TEMPORARY REVISION

Cooling system

With the introduction of new cylinder heads* for the ROTAX 912 / 914 Series the measurement position on the cylinder heads has changed. With this installation position of the temperature sensor, a loss of coolant can be recognized easily. The change to the new cylinder heads does not affect the cooling capacity.

Installation Manual part number	Chapter	Affected pages
898642	72-00-00	3
	75-00-00	3, 5, 7,8 , 11
	76-00-00	3, 4

Regarding change of temperature sensor position, see Fig. 1 and Fig. 2.

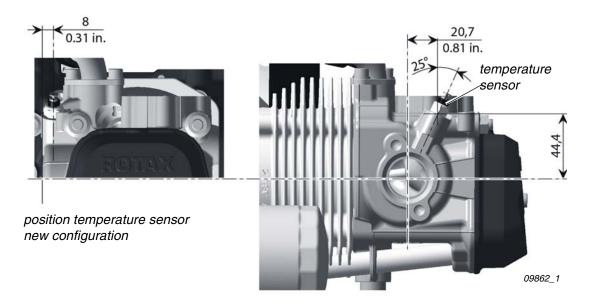
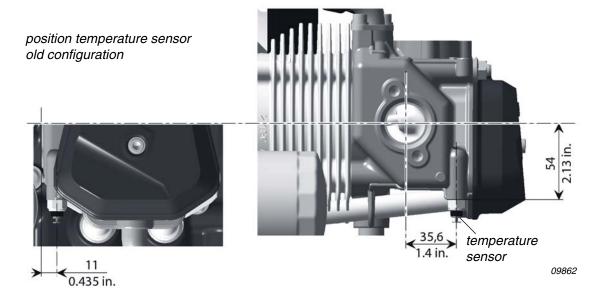
It is NOT mandatory to retrofit engines with the old cylinder heads. The different versions of the cylinder heads can be mixed installed, but make sure, if and at which position the cylinder head temperature and coolant temperature is measured. This also defines the denomination of the indicating instrument with the appropriate temperature limit.

Fig. 4

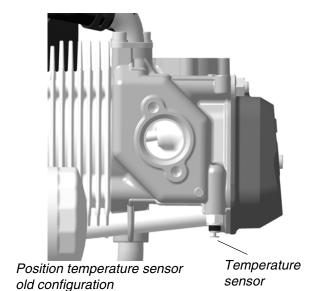
Position temperature sensor new configuration

The temperature sensor (1) is directly fitted into cylinder head i.e. the temperature of the coolant temperature is measured directly.

The temperature sensor part no. 965531 and its connection remain unchanged. In case of a retrofit / repair / overhaul the installation and maintenance-related changes should be considered and taken into account. If a cylinder head of the new version is installed at the position where the temperature is measured, specific changes in the sensor position and wiring will be necessary.
